TECHNICAL MEMORANDUM

Re: March 15, 2006 Crisp Avenue Field Visit

Date: March 20, 2006

HUNTERS POINT SHIPYARD DEVELOPMENT PROJECT		SCALE	1"=20'
FIGURE 2		CONTRACT	01-19-06
8" WATER SERVICE CRISP AVENUE		PROJECT	1
		DESIGN	W001

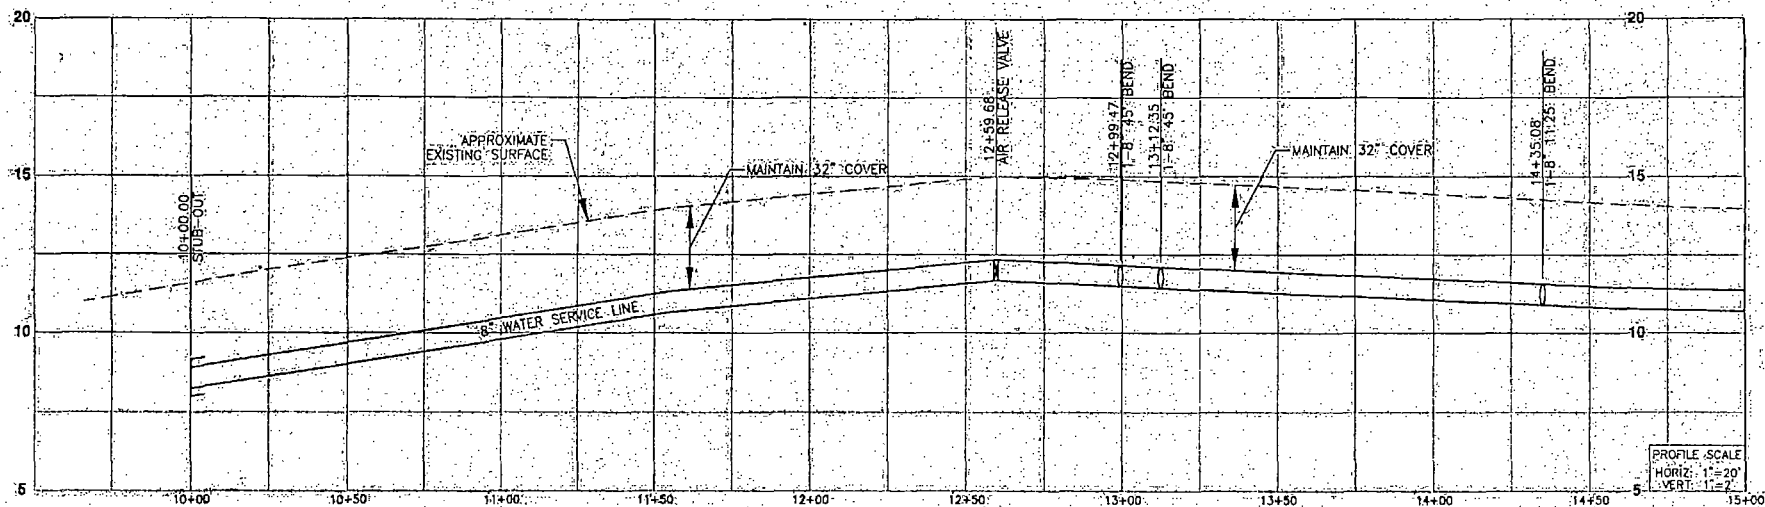
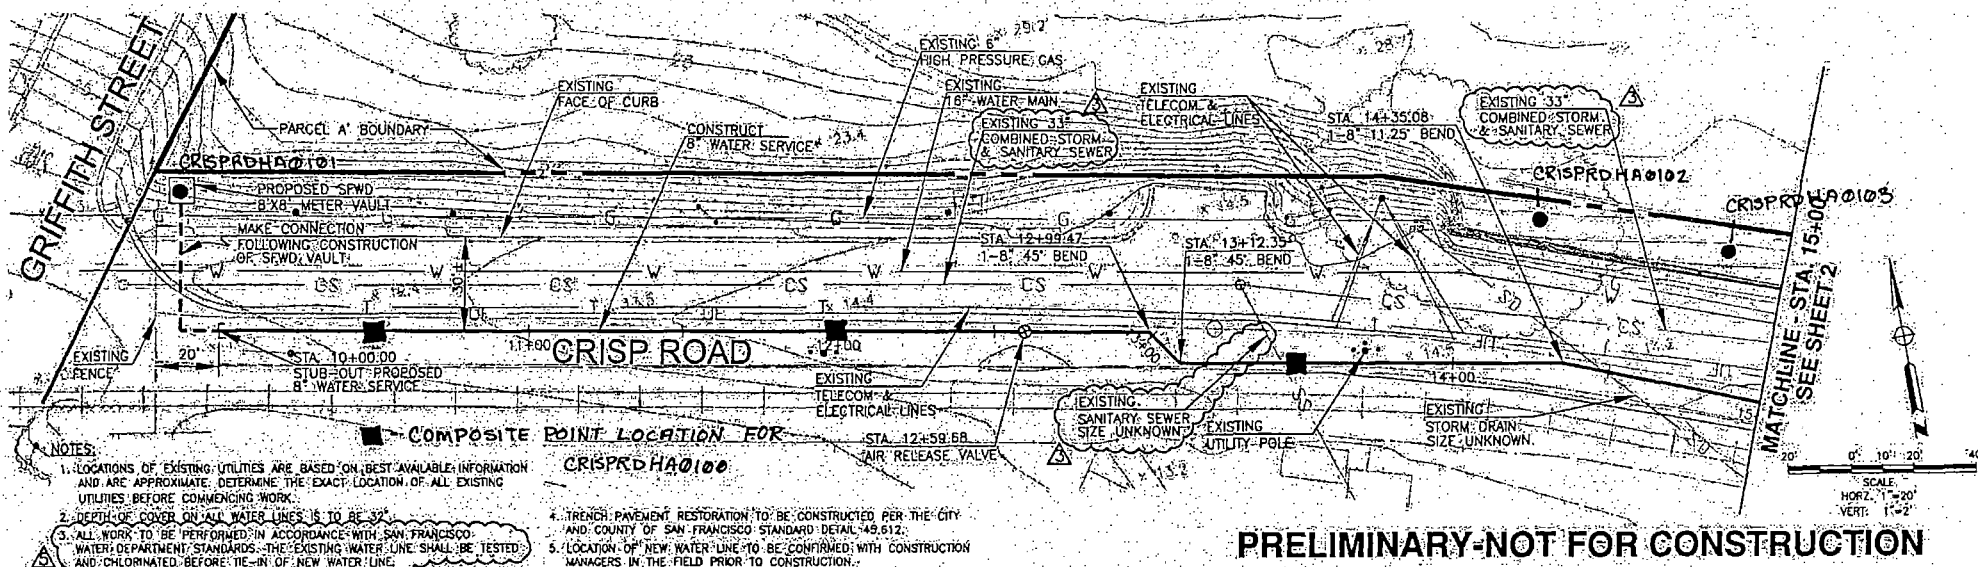
Figures 2 and 3 show the location of the new 8 inch water line (WSL) as a bold line and the existing 8 inch water meter and WSL (Figure 3). From the corner of Crisp and Griffith, the line traverses the southern edge of Crisp about 5 to 10 feet from the IR-52 boundary (assumed to be the fence between the Crisp and the railroad tracks). The WSL will abut the IR-52 boundary in the vicinity of Building 820 (the building just west of the UCSF compound). The photograph of Pothole 3 shows the WSL at the fence. This pothole marks the crossing point for a Sanitary Sewer (SS) line (see Figure 2); the SS asphalt patch is seen in the photo "Pothole 3." It is possible that there is abrasive blast material (ABM) in this pothole (see Photo "Sand in Pothole 3"); the sand was a uniform grain size and it appears that the rocks visible in the photo had fallen in from above.

A jog in the WSL to the center of Crisp required an exploratory trench to locate underground utilities (Figure 3 and Photos "WSL jog and GMP" "WSL jog and Trench"). The western most gas monitoring probe (GMP) for IR01/21 is located within 10 feet of the jog in the trench, the other probes are more than 20 feet from the new WSL. The WSL continues down the middle of Crisp, and then jogs again to the point of connection (see Figures 2 and 3).

HUNTERS POINT SHIPYARD DEVELOPMENT PROJECT		SCALE	1"=20'
FIGURE 3		DATE	01-19-08
8" WATER SERVICE		BY	2/
CRISP AVENUE		2/	W002

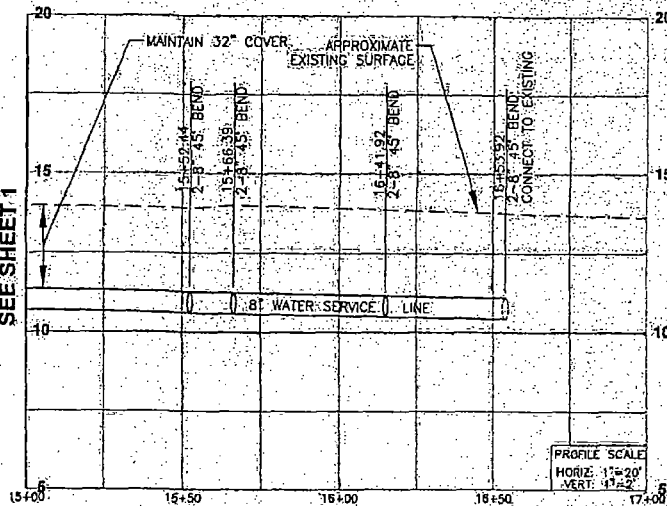
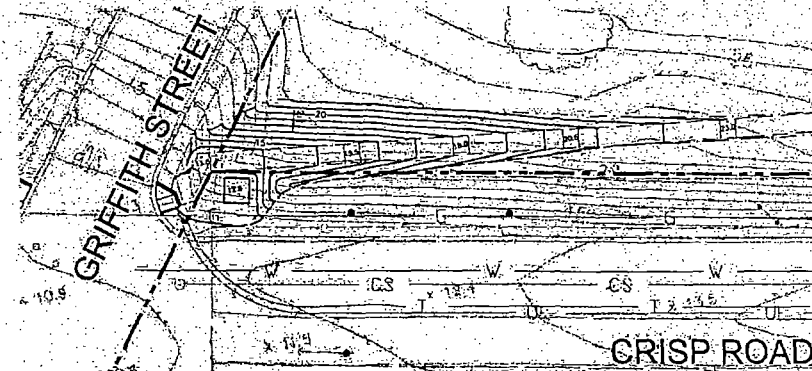
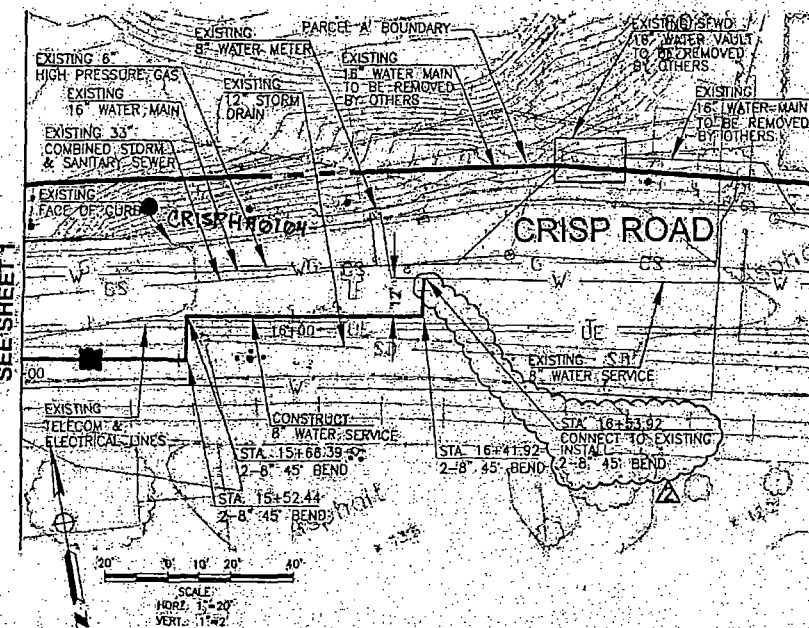
The city will install the water vault and meter at the corner of Crisp Ave. and Griffith Rd. (see proposed grading drawing on Figure 3); Lennar does not know how deep the city will excavate here. North of the UCSF compound, slope stability grading of the hillside will require additional removal of Parcel E soil to a depth of one to two feet below ground surface (ft bgs) from the north curb of Crisp Ave. to retaining wall H (see construction drawings SD-B and SD-5). This will begin at the connection point of the 8 inch WSL (see photo “Point of Connection” – the existing meter is located under steel plates in front of blue truck). The existing water vault in this area will also be removed (see Figure 3 and photo “Water Vault”).

Finally, an exploratory trench was opened under the sidewalk on the north side of Crisp Ave, near the concrete lot west of former Building 816 (see photo “16 Inch Cap”). The trench exposes a 16” water line that supplies the existing water vault. The 16” line will be capped at this point, the remainder of the line (to the west) and the water vault will be removed from Parcel E (see Figure 3).
